Access Compliance Report

Public Rights-of-Way

Intersection ID: N/A	Main Street: BROOKSVALE_ST	Cross Street: N/A	Location: SW
ADA ID: 8A99A54FC242	Ramp Type: Perp	Initial Pass/Fail: Fail	Overall Compliance: No
Severity Score: 13.75			
Codes/Mitigation Info/Possible Solution		Field Measurements/Component Compliance

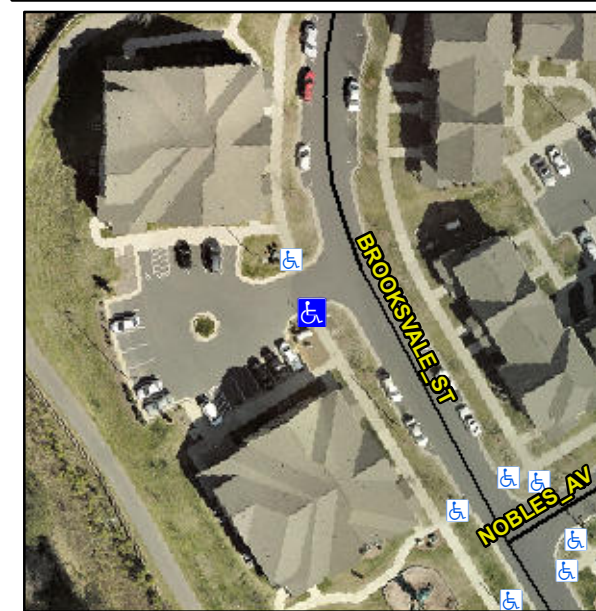
R304.2.2, R304.5.3

Compliance	Description	Data	Compliance	Description	Data
N/A	Ramp Length (in)	72.0	No	Ramp Slope (%)	8.9
Yes	Ramp Width (in)	70.0	No	Ramp XSlope (%)	2.2
N/A	Flare Type LT	N/A	N/A	Flare Type RT	N/A
N/A	Flare Slope LT (%)	N/A	N/A	Flare Slope RT (%)	N/A
N/A	Flare Traversable LT?	N/A	N/A	Flare Traversable RT?	N/A
N/A	Landing Length (in)	N/A	N/A	DWS Provided?	N/A
N/A	Landing Width (in)	N/A	N/A	DWS Contrast?	N/A
N/A	Landing Slope (%)	N/A	N/A	DWS Length (in)	N/A
N/A	Landing X Slope (%)	N/A	N/A	DWS Full Width?	N/A
N/A	Landing Curb? (Y/N)	N/A	N/A	DWS Offset (in)	N/A
N/A	Shared Landing?	N/A			
N/A	Gutter Ponding?	N/A	N/A	Gutter Slope (%)	N/A
N/A	Gutter Lip Ht (in)	N/A	N/A	Gutter X Slope (%)	N/A
N/A	Painted X Walk1?	No	N/A	Painted X Walk2?	N/A
	X Walk 1 Direction	To N		X Walk 2 Direction	N/A
N/A	X Walk 1 Width (in)	N/A	N/A	X Walk 2 Width (in)	N/A
	X Walk 1 Slope (%)	3.3		X Walk 2 Slope (%)	N/A
	X Walk 1 X Slope (%)	1.0		X Walk 2 X Slope (%)	N/A

Remove & Replace Entire Ramp.
